**SUPPLEMENTAL
ENVIRONMENTAL IMPACT REPORT**

SILVA VALLEY PARKWAY INTERCHANGE PROJECT

FINAL

FIGURE 3

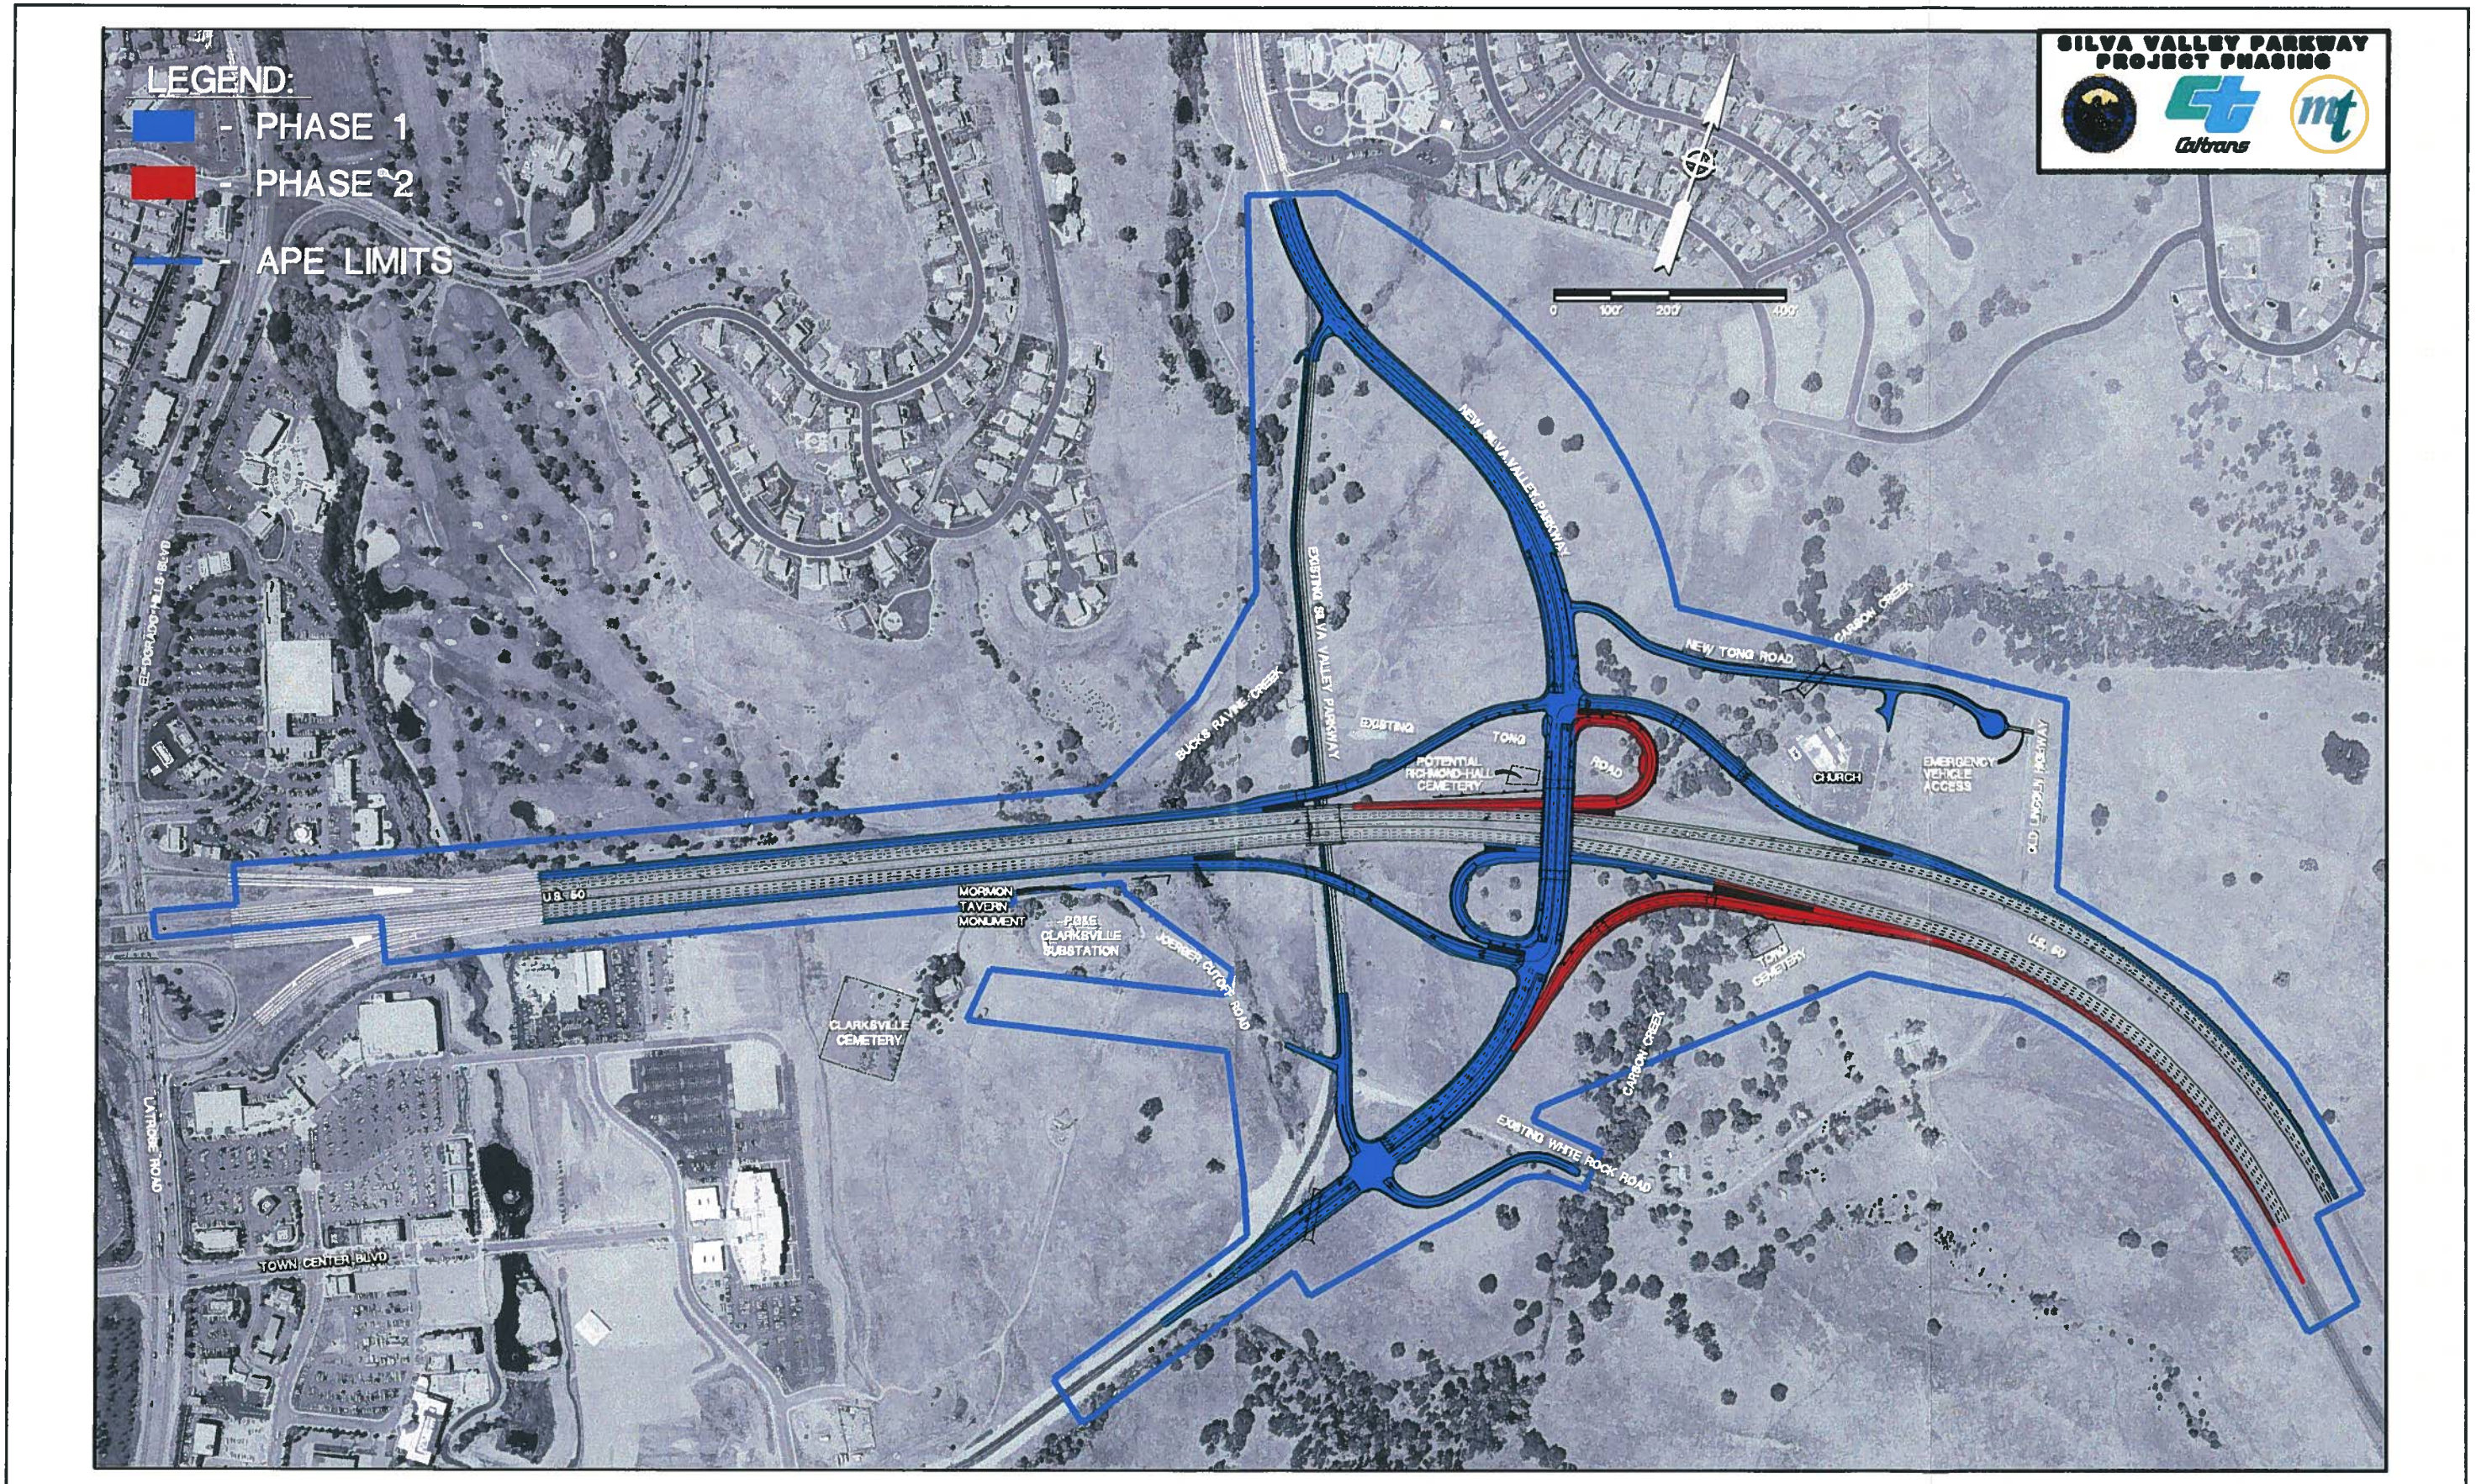
Figure 2 (page 9 of the LSA report), Figure 3 (page 11 of the LSA report) and Figure 1A (page 2 in the Traffic Study) appear to be inconsistent as it relates to Tong Road and Country Club Drive. The text of both reports, which refer to the above figures, also appears to be inconsistent. These inconsistencies make it difficult to understand how interim and permanent access to the parcels in the northeast quadrant of the interchange will be provided. Please clarify.

Also, please clarify the phasing of the improvements. Figure 3 of the LSA Report shows the westbound loop ramp and eastbound direct ramp as the last phase, whereas Figure 1a of the Traffic Study shows both loop ramps as the last phase. Please clarify.

KB-1: The SEIR prepared by LSA is the most recent and therefore most accurate report. Figure 3 of the LSA report gives the most accurate representation for the re-alignment of Tong Road as it relates to the adjacent parcels. All of the parcels, which take access from the existing Tong Road, will continue to receive access. A future separate project is proposed to build Country Club Drive, which will provide access to parcels northeast of the Silva Valley Interchange project.

KB-2: The proposed project was originally planned to be constructed in three phases. The project has since been revised to include only two phases. Therefore Figure 3 of the LSA SEIR represents the most accurate phasing plan for the project.

FIGURE 4

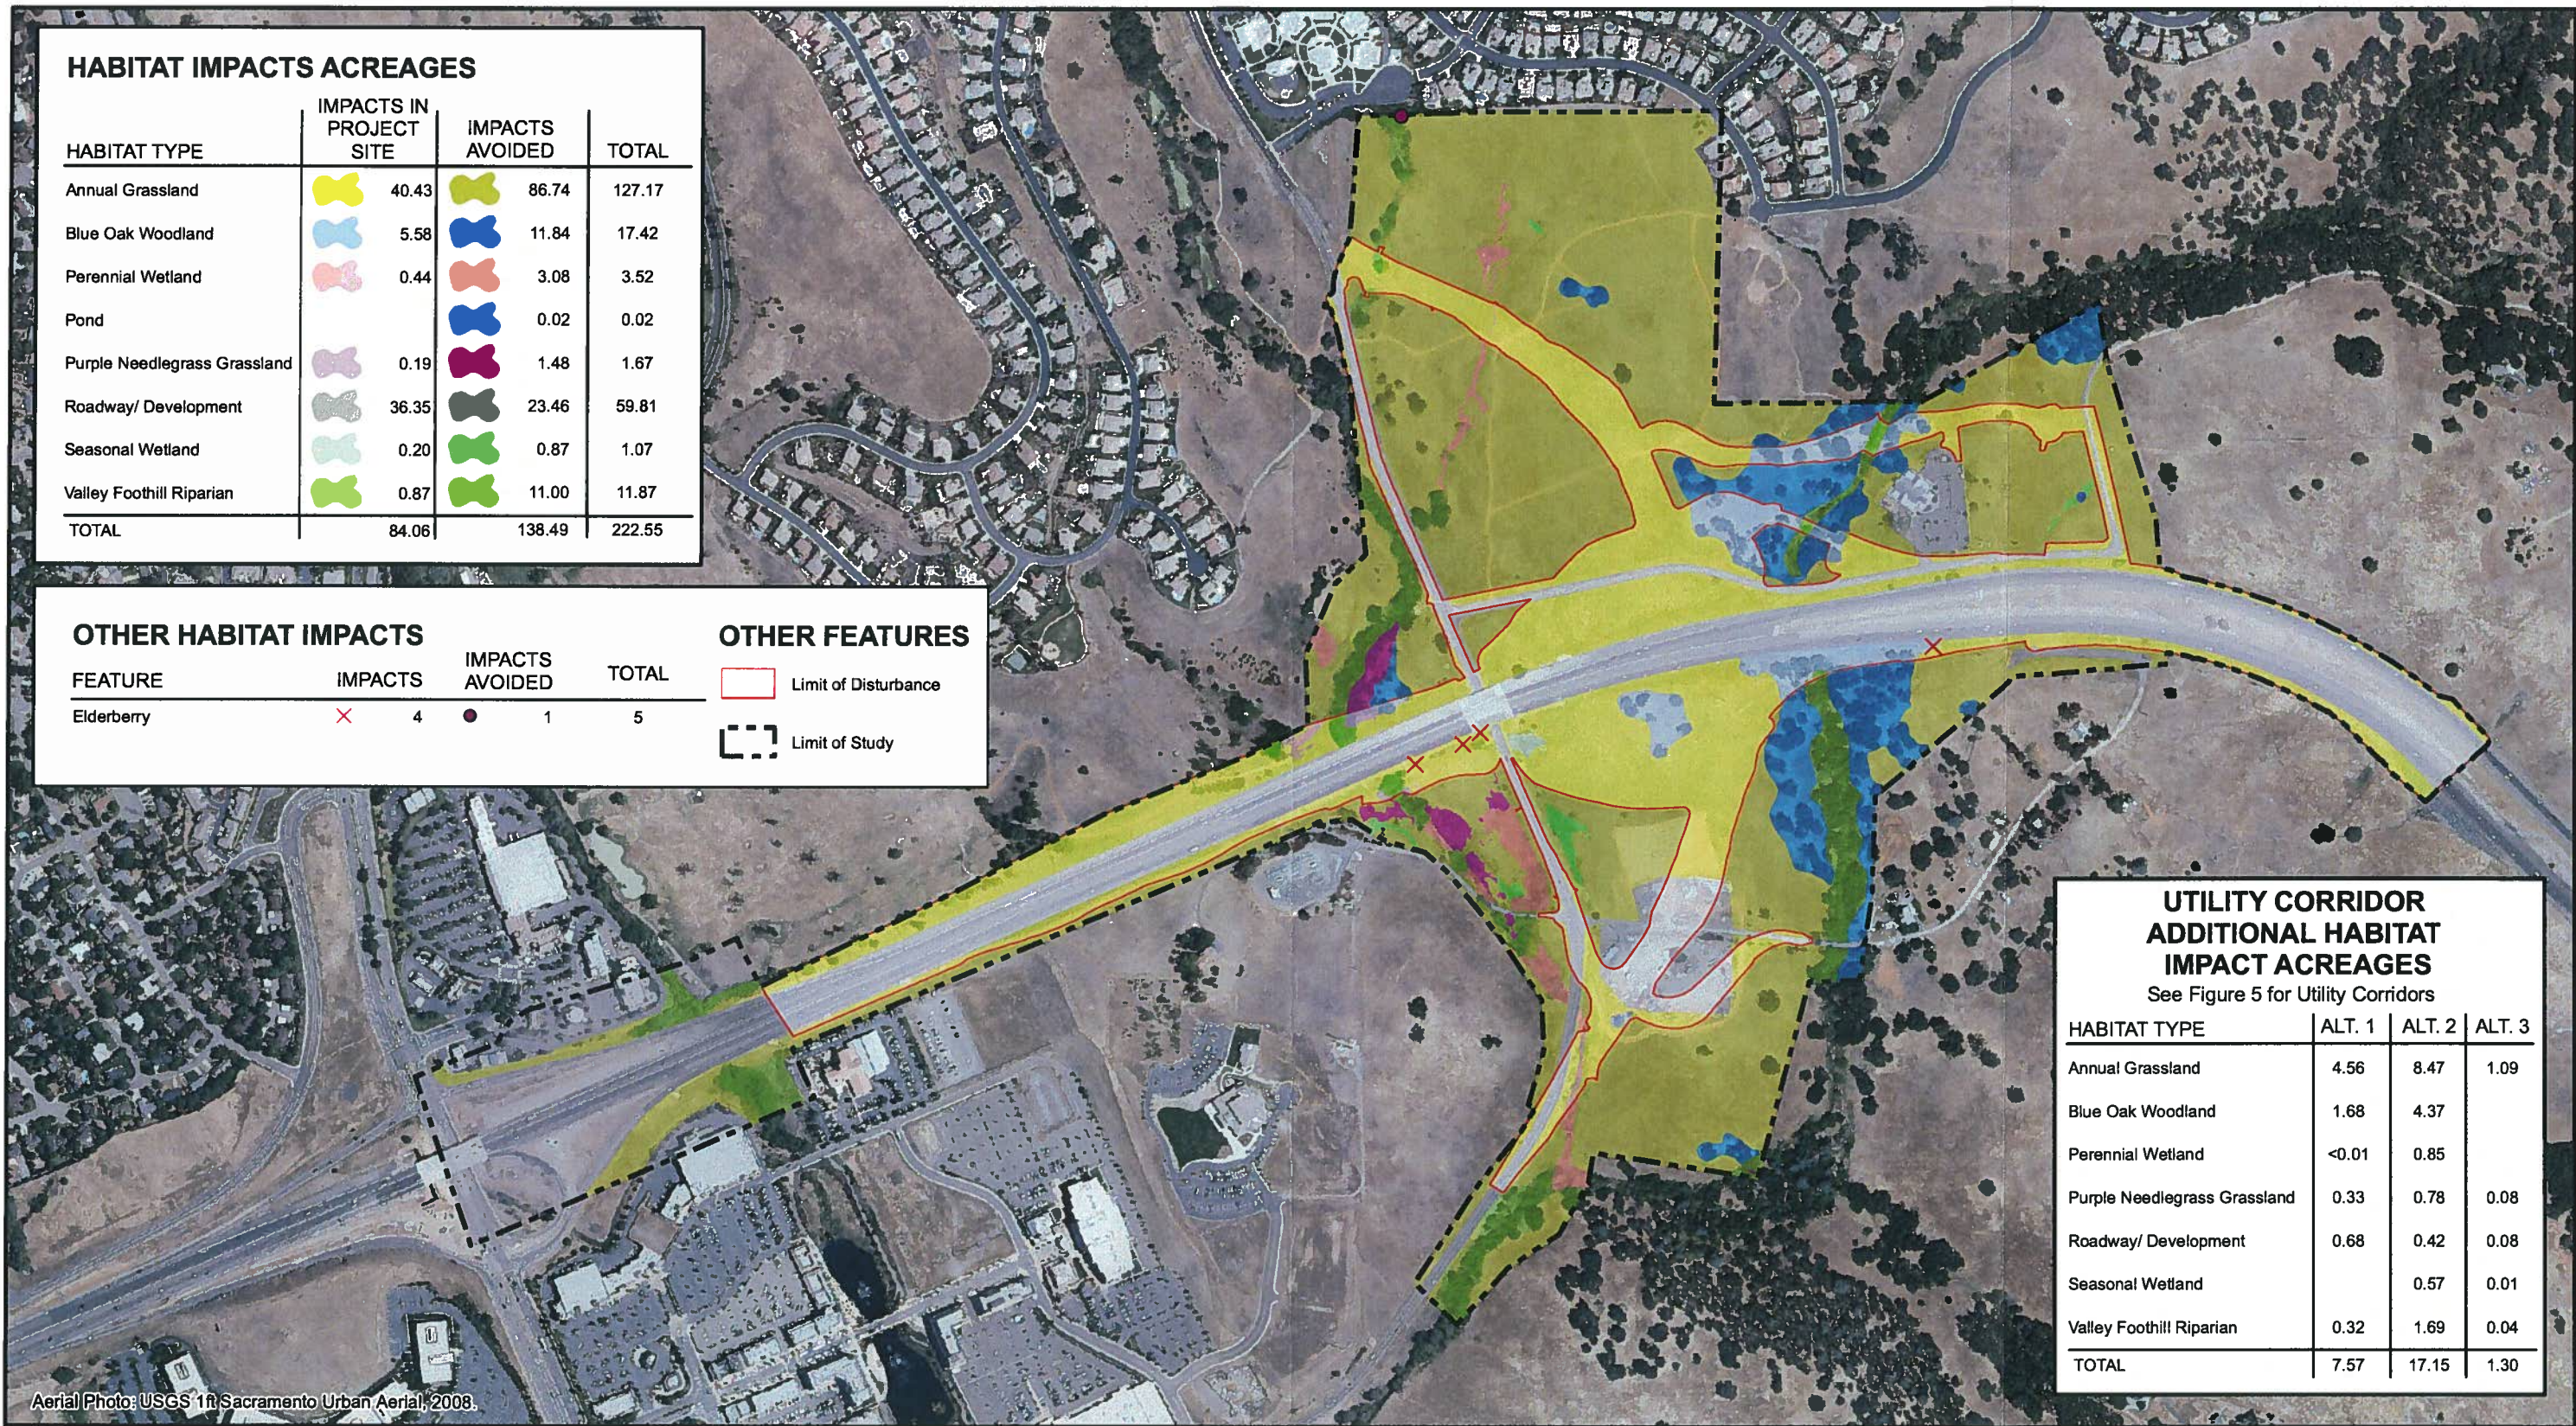
Page 42 – *Figure 4: Utility Corridor Additional Habitat Impact Acreages* identifies the Limit of Disturbance (LOD) for the proposed Project activities. However, the LOD does not include all of the EID utility modifications necessary to meet public service requirements resulting from implementation of the proposed Project. The additional areas that should be included in the LOD are as follows:

Due to the additional areas being impacted by El Dorado Irrigation District utilities, minor changes to biological impacts have occurred (see revised Figure 4). Specifically, these changes include:

EID-3: Figure 4 has been amended to include EID facilities. See Errata section.
